# **The International Standard: “Reed Switches - Part 1: Generic Specification” (IEC 62246-1 Ed. 2)**

## **Critical Review**

Vladimir Gurevich, Ph. D.,

Israel Electric Corporation

Fig. 3. Experimental curves gained for reed switches of different types and sizes and manufactures by the different companies in the different countries.

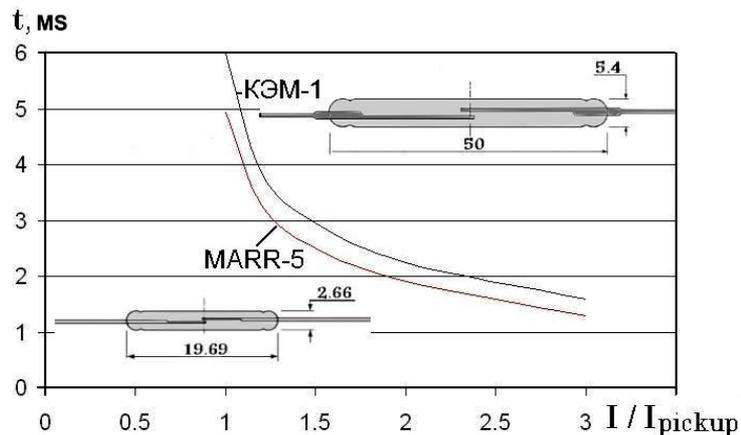
It is necessary to note that in the theory of a reed switches there are two principal causes for sticking: the first is the magnetostrictive effect which is a grinding of the contact surfaces after repeated wear and remaining in the closed position under act of molecular forces, and second is electric erosion of contacts at DC switching in which an acute ledge is formed on one of contacts, and a crater on other. The pinching of this ledge in the crater leads to a sticking reed switch. What “thermal sticking” is we do not know and efforts to find any reference presenting this phenomenon in the technical literature have been to no avail. The other matter, magnetomotive force of making (ampere-turns to make), depends to a strong extent on the reed switch temperature owing to changes of the magnetic properties of a ferromagnetic material from which the contact-elements are manufactured, Fig. 2. On the market there are even special, so-called “thermal reed switches”, operating at certain temperatures and used as temperature sensors. On the other hand, it is known, that the turn-on time of reed switches strongly depends on the rate of the current in the control coil, i.e., at the magnetic field level, that is abruptly applied to them, Fig. 3. Therefore, it is abundantly clear that a change of a magnetic condition of the contact-details under the affect of temperature will also change the turn-on time of the reed switch. This change, however, has no relation to reed switches sticking.

Thus, instead of the analysis of one of the most common reasons for reed switches sticking - electric erosion of contacts, the standard invents some new aspect of reed switch sticking, not known in the technical literature.

Fig. 5. Standard waveshapes for testing surge immunity (according to IEC 61000-4-5).

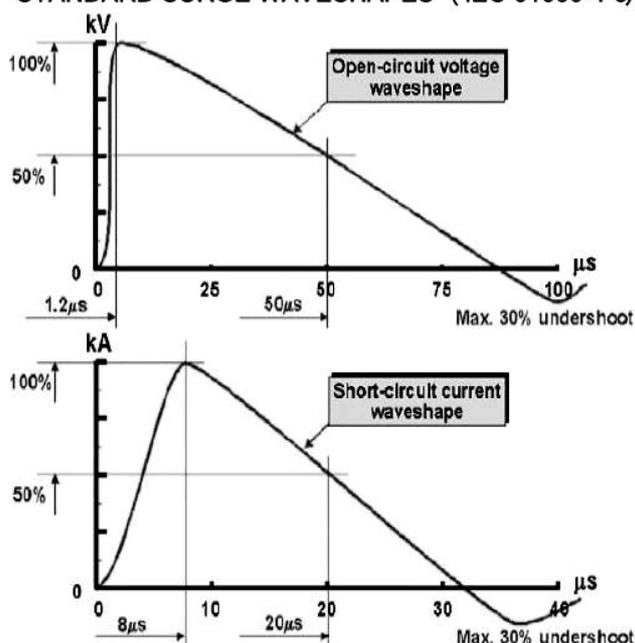
Only a specialist in the field of the electro-magnetic compatibility (EMC) may understand what this list means, but by no means the specialist in the field of reed switches.

Why are there no references in these sections to the matching standard: IEC 61000-4-5, which presents, in detail, a technique of conducting of such tests and parameters of test pulses?

Why are there no explanations for  $t_1$  and  $t_2$  as earlier the same designations were applied in the standard to make and break times (see Fig. 2 in Section “Terms and Definitions”)? Why as the parameters of a test pulse (in the given context  $t_1$  and  $t_2$  are the times describing pulse rising edge and pulse decreasing edge of the high-voltage test pulse) are the parameters of the pulse known as “telecommunication pulse”? Are such pulses used for testing the radio-electronic and communication equipment, in contrast to a standard pulse 1.2/50  $\mu\text{s}$ , Fig. 5, used for testing electrotechnical equipment such as the relays, contactors, switches, buttons, etc.? Can the miniature reed switches, for example, ORD213, MITI-3, RI-70, KSK-1A80, HSR-0025 and dozens of other types with breakdown voltages of 100 - 200V, withstand an impulse voltage 1000V? On the other hand, what test using a 1500V impulse voltage will verify vacuum reed switches with rated voltages of 5,000 or 10,000V?

Fig. 6. Oscillograms of switch-on and switch-off processes in the reed switch  
 $t_5$ ;  $t_6$ ;  $t_{15}$ ;  $t_{16}$  – contact bounce times (Fig. 2 from standard IEC 62246-1 Ed.2)

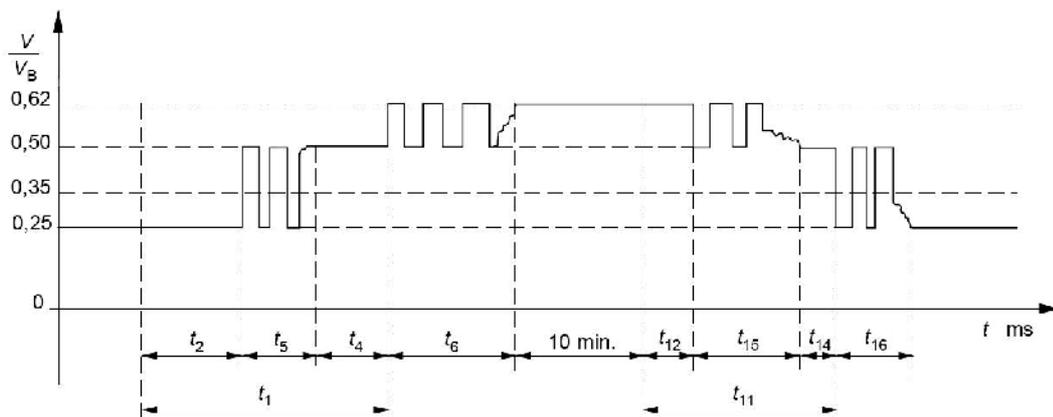
And further, what does the note about “without breaking applies” and “without making applies” in the procedures mean for making and breaking current capacity test (Sections 7.32.2 and 7.33.2)? How it is possible to realize this demand practically, if, according to the standard’s claim (Section 3.2.13, Fig. 2), the switching process is always accompanied with contact bouncing? In contrast to Fig.2, the figure in Annex G (Making current capacity test sequence) and the figure in Annex H (Breaking current capacity test sequence) do not include contact bouncing. So, which figure is correct?

It is absolutely clear that all these Sections need to be completely rewritten.
